FEC-protected chip-to-module CAUI-4 specification

Piers Dawe

IEEE P802.3bm, Jan 2014, Indian Wells

Figure 83E-1—CAUI-4 relationship to the ISO/IEC Open System Interconnection reference model and the IEEE 802.3 CSMA/CD LAN model

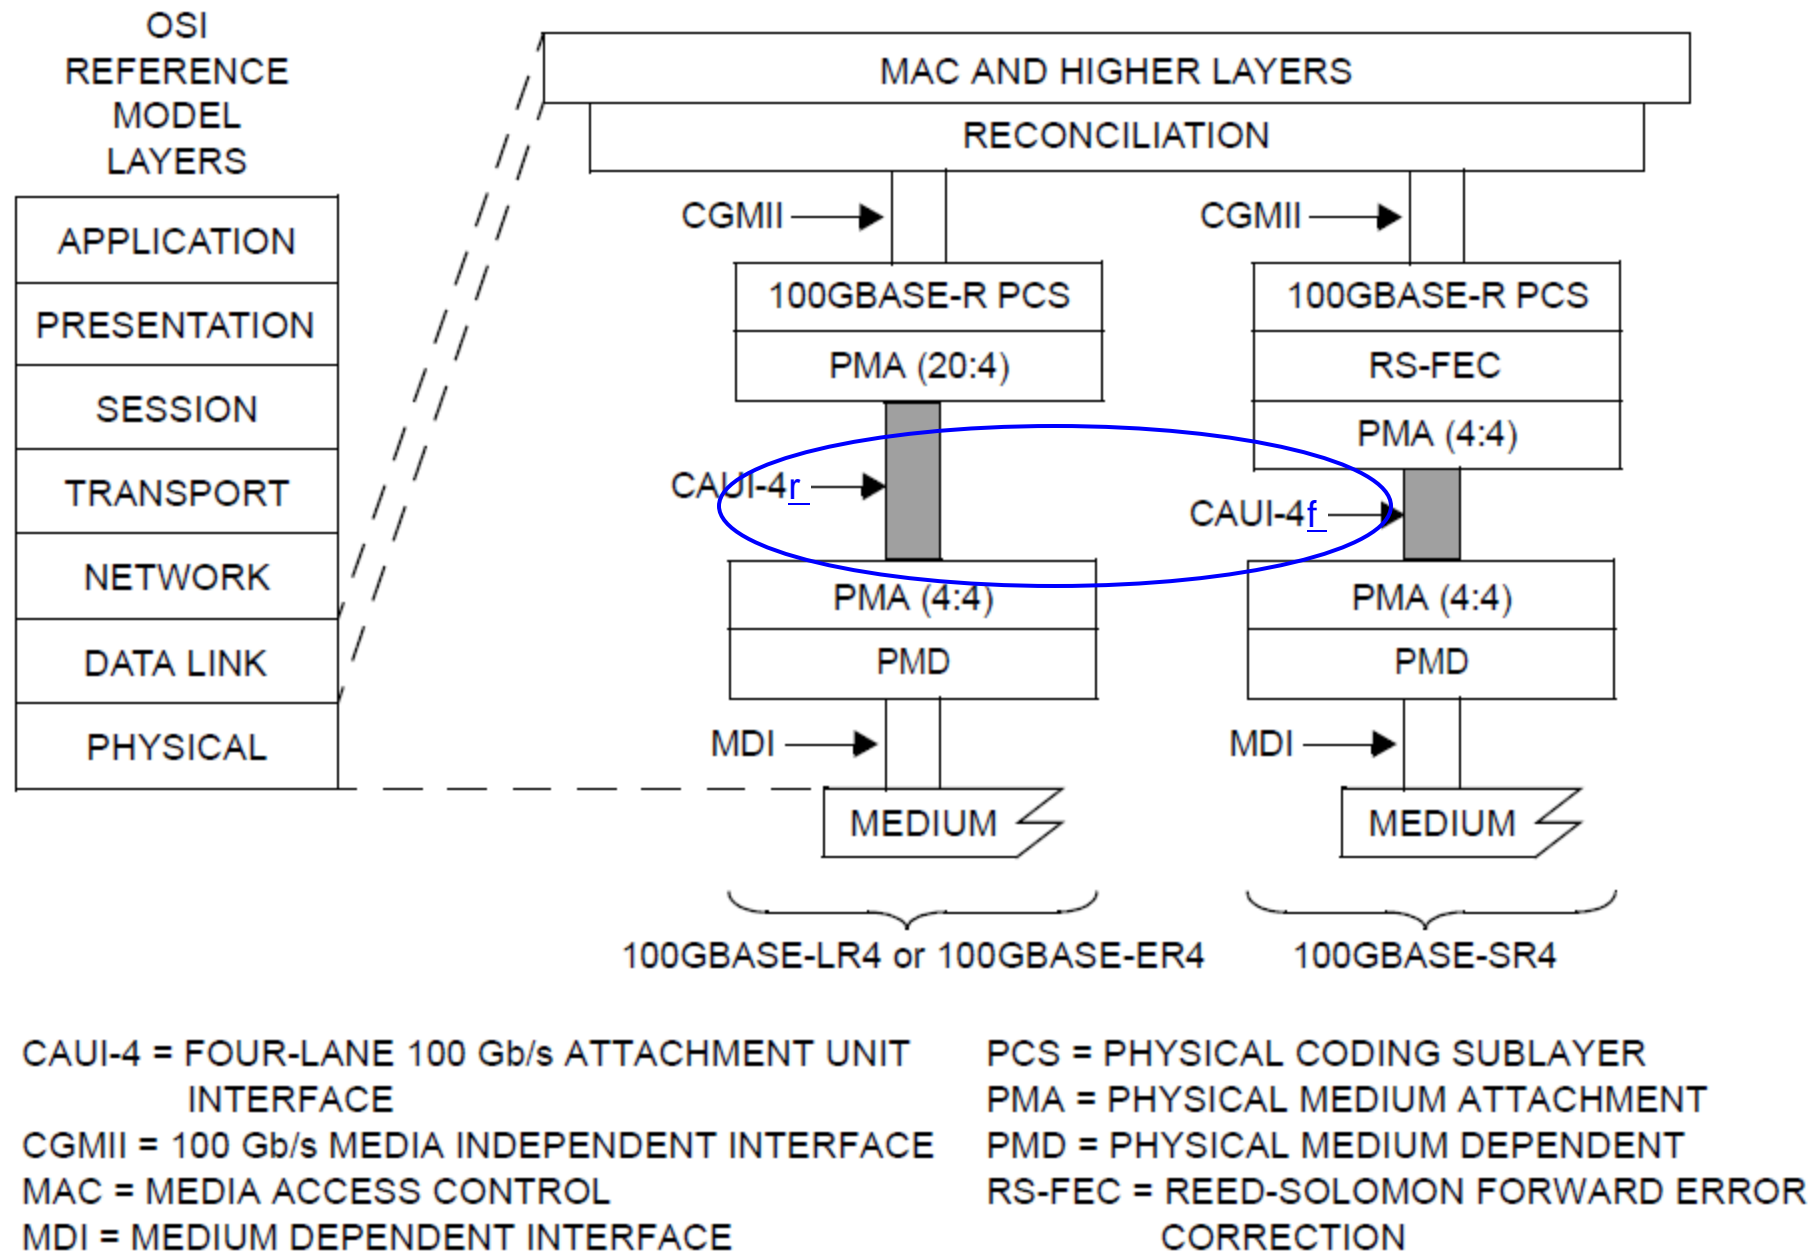
- In 802.3, an interface is specified "logically" (what bits and coding) as well as, often, timing and electrical specifications
- Annex 83E contains two things, at present both using the same name
 - One with FEC,
 - One without
- We could name them CAUI-4f for the RS-FEC protected interface and CAUI-4r for the unprotected (raw, R-encoded) interface
 - Or CAUI-4p and CAUI-4u
 - The FEC status across the host-to-module connection (FEC coded or not?) needs to be determined anyway: must be same for host and module

... The nominal signaling rate for each lane is 25.78125 GBd. There are two variants of chip-to-module CAUI-4; in CAUI-4r the signal is not RS-FEC encoded, and in CAUI-4f the signal is RS-FEC encoded. An electrical interface that is compliant to CAUI-4r would also be compliant to CAUI-4f if the signal were RS-FEC encoded.
